Peer Review of the Lake Avalon SSARR Model

The St. Johns River
Water Management District

August 2009

Figure 1. Lake Avalon SSARR Model Schematic. Source: (Robison, 2008)

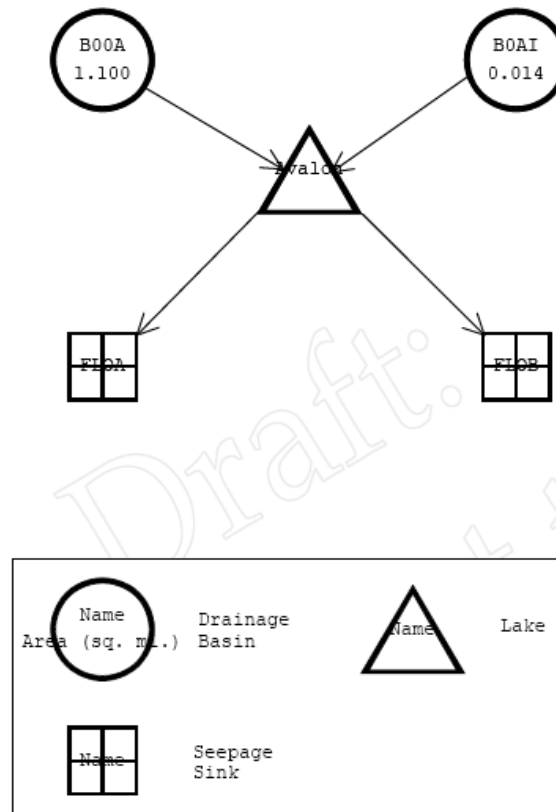
Model Conceptualization. The model schematic is shown in Figure 1. The input to the lake consists of a previous basin and impervious basin consisting of areas of 1.10 and 0.014 square miles, respectively. Outflow from Lake Avalon flows to two sinks: one permanent sink (the Floridan aquifer), and one temporary sink, which is active below 84 feet NGVD. The second sink was added to the model during the calibration process because the simulated stages were systematically diverging from observed values at stages lower than about 84 feet. The development of this additional sink essentially assumes that the model breaks up into two separate lobes at stages lower than 84 feet. While this may be a valid assumption, if the lake breaks up into

2 separate lobes, the drainage areas should also be broken up into a pervious and impervious basin for each lobe. Otherwise, when the temporary sink is inactive, the model is utilizing the drainage areas for both lobes of the lake and applying the runoff generated to the actively seeping lobe. In reality, a portion of that drainage area is contributing to the other lobe. The effect of this is that there could be too much runoff contributing to the actively seeping lobe.

An alternate methodology for simulating 2 lobes of the lake would be to simulate the lake as 2 separate lakes that are connected above a specified elevation. This would eliminate the errors associated with the entire basin contributing one lobe of the lake when the temporary sink is inactive.

Figure 2. Comparison of L-052 and Clermont Wells. Source: (Robison, 2008)

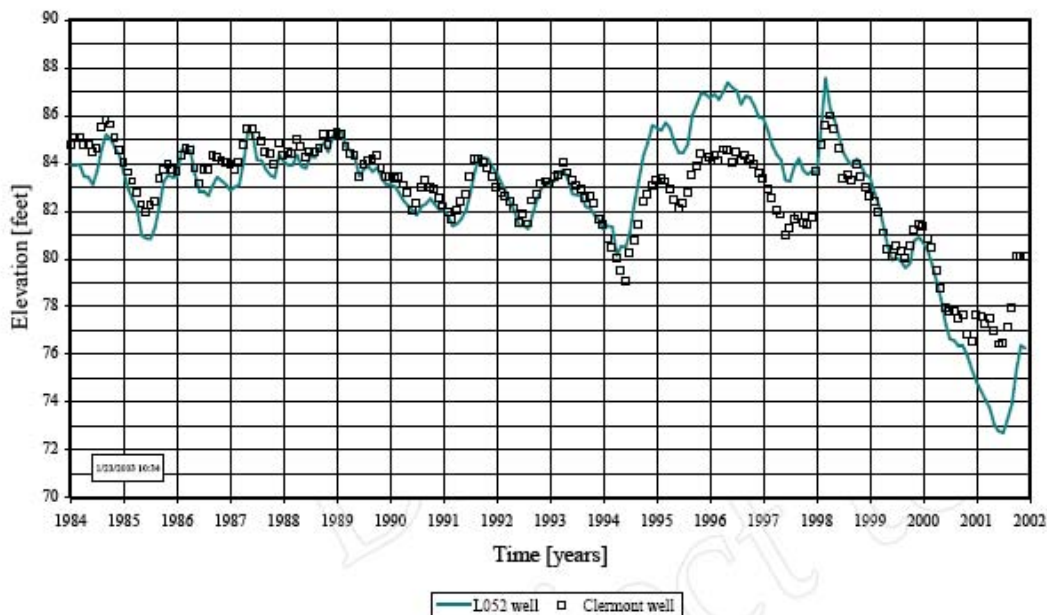
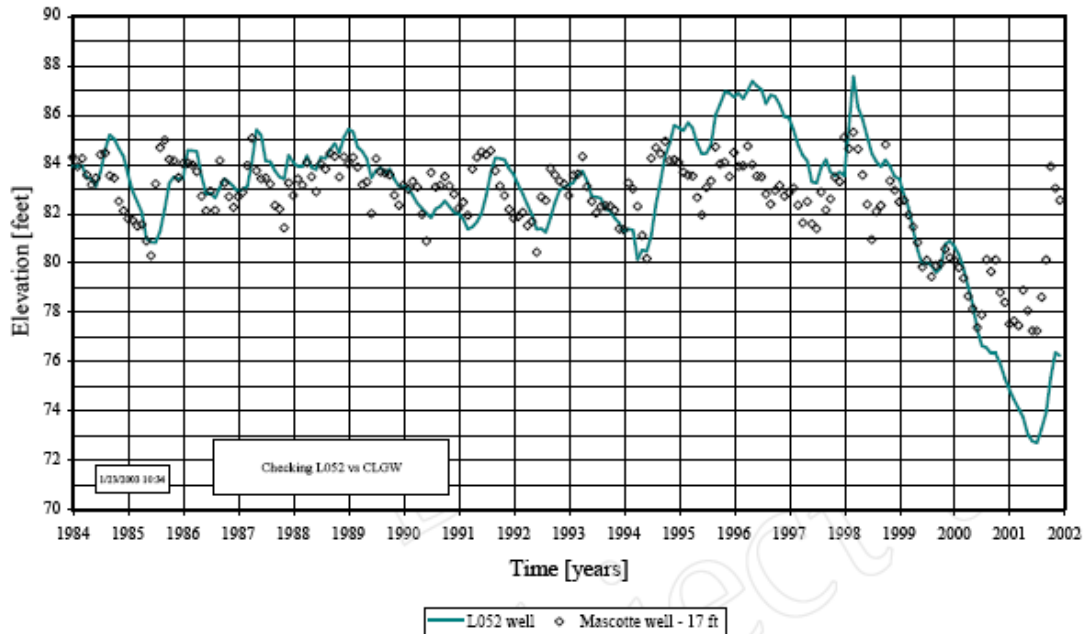
Utilization of L-052 Well Data. Data from the District's L-052 well was utilized for the calibration period (1989-2001). This data consisted of a monthly record with some additional data gaps. Linear interpolation was utilized to fill daily values between monthly readings. More information is needed with regards to why this well was chosen for use as the primary data source for potentiometric surface in the model. Based on the available well data shown in Table 1, there are more complete well records available. Comparison of the L-052 well data to the Clermont and Mascotte wells is shown in Figures 2 and 3, respectively. As shown in the figures, there is a good comparison between the L-052 and Clermont well records, with the exception of the higher stages recorded at L-052 in the 1990s (1995 and 1998) and the much lower levels recorded at L-052 in the early 2000s. It would be highly useful to run the model with one of these available well records (such as the un-shifted Clermont well) in order to determine the impact of using the L-052 well time series.

For the extended simulation (1959-2001), the Clermont and Mascotte wells were used to supplement the L-052 record. More information is needed in order to determine how the L-052 record was supplemented. As shown in the figures, although there is generally good agreement for the time series between the L-052 and Clermont and shifted Mascotte well, there are periods (such as in the 1990s and early 2000s) where there is a greater range of elevations shown at the L-052 well than the other 2 wells. When data from one well is supplemented with data from another, it is important to scale the data by both shifting the data based on the potentiometric surface difference, and scaling it by a factor to preserve the range of values seen at the original well. This will ensure that the characteristics of the original well (L-052) are preserved. A comparison of the approximate minimums, maximums, and well ranges is shown in Table 3. As shown in the original table, although the wells generally compare favorably, the more extreme events seen at the L-052 well result in a much greater range of values than at the other 2 wells.

Based on the model documentation, it appears that a shift was applied to the Mascotte well, but no other processing was done. If this is the case, it would be beneficial to develop a time series for the extended simulation that also preserves the range of the L-052 record. This would be a fairly straightforward algorithm to run and would not require a great deal of additional effort. The SSARR model can be re-run with this new time series, and the difference in the lake stages between the two runs can be compared in order to determine the impact of developing a time series that preserves the original well characteristics.

Figure 4. Lake Avalon Stage Area Curve. Source: (Robison, 2008)

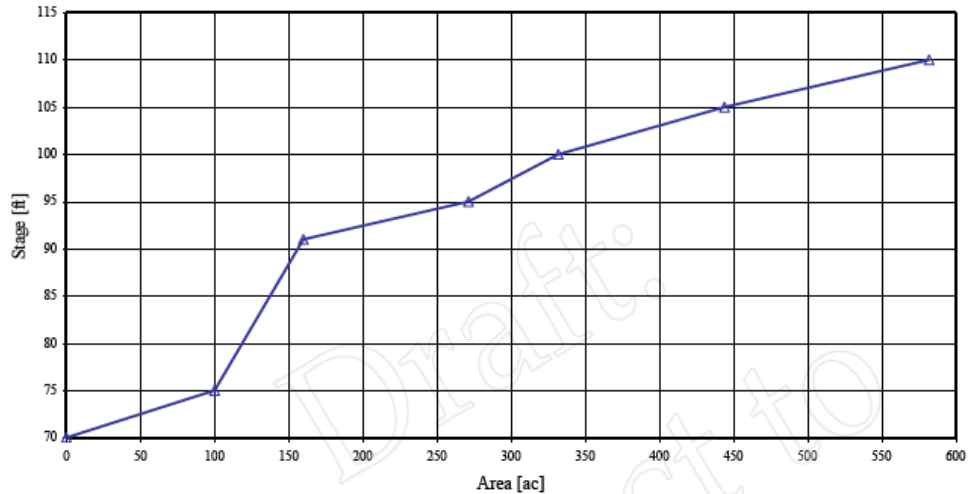
Change in Basin Area based on Lake Stage. The stage-area curve for Lake Avalon is shown in Figure 4. As shown in the figure, the area of Lake Avalon ranges from over 550 acres at a stage of 110-feet to an area of 100 acres at a stage of approximately 75-feet. During the calibration period, the lake stage ranged from approximately 80-feet to 92-feet. These stages correspond to lake areas of approximately 115 acres and 215 acres, respectively. Table 4 shows the range of the lake area during the calibration period as well as the areas of the basins used in the model. As shown in the table, the variability in the lake area represents a large percentage of the contributing basin. When the stage of the lake goes down and decreases the lake area, there is a decline in lake area of approximately 100 acres (from high stage to low stage). This additional area should be added to the pervious basin area since it is still contributing to the overall basin. Although SSARR has the ability to change the area of the lake with stage (for lake water budget calculations such as direct evaporation), when the lake stage is low, for example, it does not add the reduced lake area to the pervious basin area (thus causing a mass balance error). This is particularly important since the basin is small, and an additional 100 acres represents a large percentage of the pervious area. It might be noted that, in the lake water balance, direct precipitation is offset by direct ET from the lake. The assumption can be made that the error in mass balance would be negligible given the fact that precipitation and ET are similar on an annual average. Given the timing differences in rainfall and ET, however, the assumption that changing the lake area does not affect the overall water balance is wrong. With the base area of the lake of 180 acres and the lake area ranging from 115 to 215 acres during the calibration period, the corresponding change in the pervious basin would be from 769 acres (at low stage) to 669 acres (at high stage). This represents a range of change in the pervious basin from +9.2% to -5.0%.

Figure 5. Observed and Simulated Hydrographs (Calibration Period). Source: (Robison, 2008)

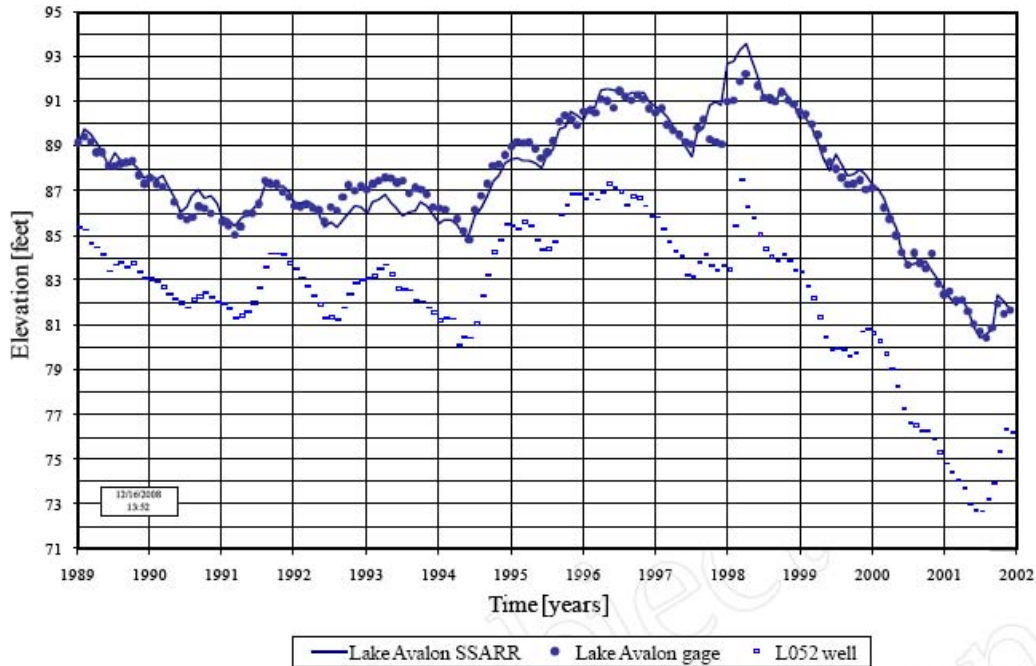
Comparison of Long Term Simulations. A comparison of the Lake Avalon SSARR results to the Lake Avalon gauge for the calibration period is shown in Figure 5. As shown in the figure, there is a good agreement between the observed and predicted stages for the calibration period. The results for the long term simulation are shown in Figure 6. As shown in the figure, there is no comparison of the SSARR results to observed data for the long term simulation in the original report documentation. All historical observed stage data should be added to this graphic in order to better assess the performance of the model.

Figure 6. Existing Conditions SSARR Simulation Hydrograph. Source: (Robison, 2008)

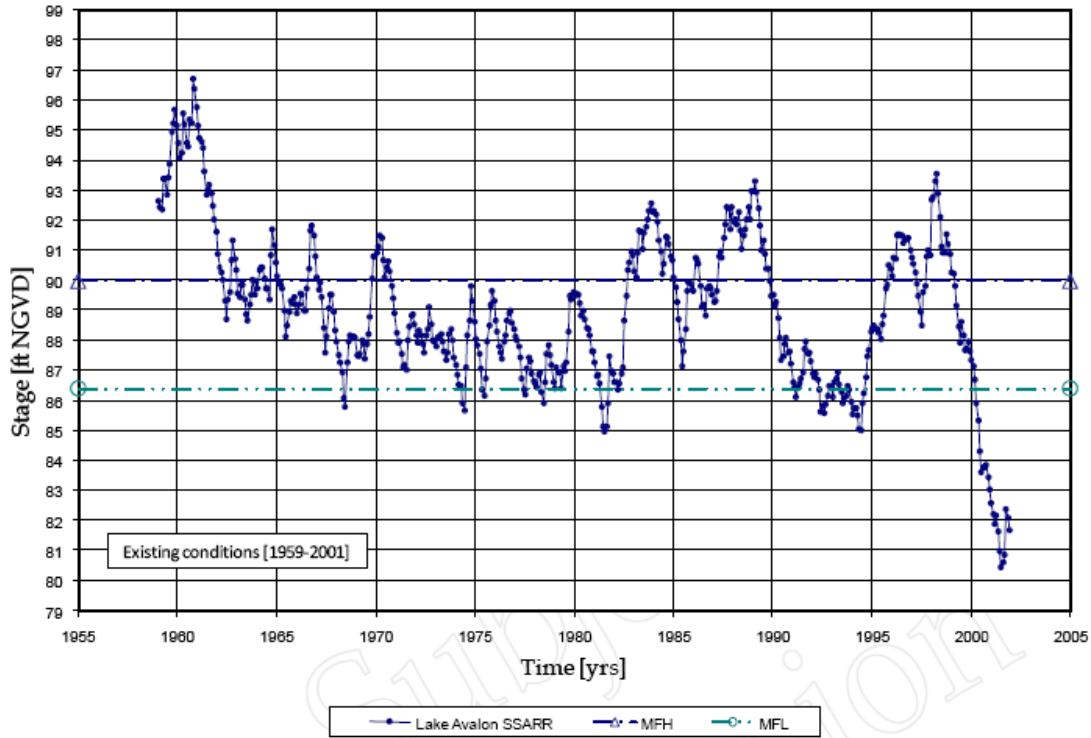
The report documentation discusses two long term simulations, as shown in Table 5. These two long term simulations utilize identical input data with the exception of the input rainfall time series, as shown in the table. In the model documentation, the output stage hydrograph is only given for the 'Existing Conditions' simulation. The output stage hydrograph for the 'Existing Conditions-Alternate' simulation should also be added to the report documentation, preferably on the same graphic as the 'Existing Conditions' simulation and the observed data. Examination of this data is vital in order to be able to assess the impact of the rainfall time series on the model.

Although the documentation does not show the stage hydrograph for the Alternate simulation, the MFL curves are developed using both long term simulations. It is important to note that the only difference between these simulations is the rainfall input time series. Despite this slight difference between the models, there are visible differences in the probability plots resulting from these simulations (and used to evaluate the MFH and MFL). The rainfall time series for each of these models should be detailed further (annual totals, event totals, etc.) in order to further investigate the differences in the simulations. Again, this recommendation is based solely on the data available in the documentation. No simulation results were given for the alternative simulation, with the exception of the MFH and MFL curves.
